NUMBER: 09-011-16

GROUP: Engine

DATE: July 07, 2016

Engine Oil Pan Replacement

Fig. 1 Oil Pan Weepage

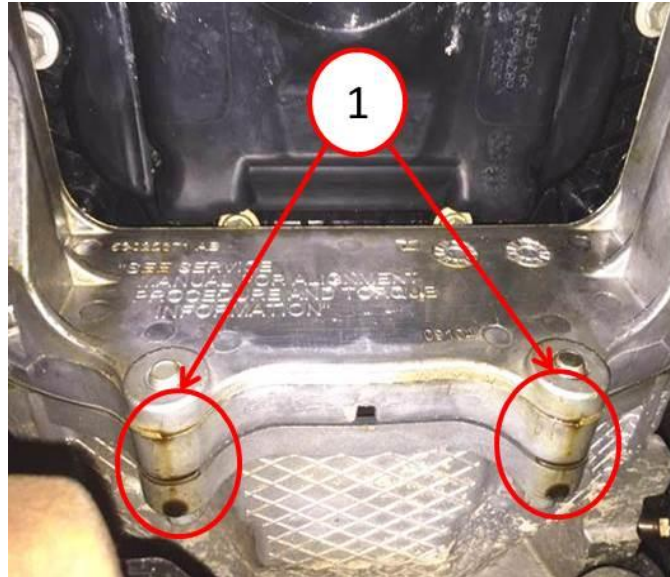
NOTE: Oil weepage is at the rear part of the oil pan and the Rear Seal Retainer (RSR) assembly.

1. Visually inspect for oil weepage. Is weepage noticed ([Fig. 1](#))?
 - a. YES >>> Proceed to [Step #2](#).
 - b. NO >>> This bulletin does not apply. Further diagnosis should be performed. Use LOP (09-60-01-9A) to close the active RRT.

1. Replace engine oil pan. Refer to the detailed service procedures available in DealerCONNECT> TechCONNECT under: Service Info> 09 - Engine, 5.7L/Lubrication/Pan, Oil/Removal/Installation.
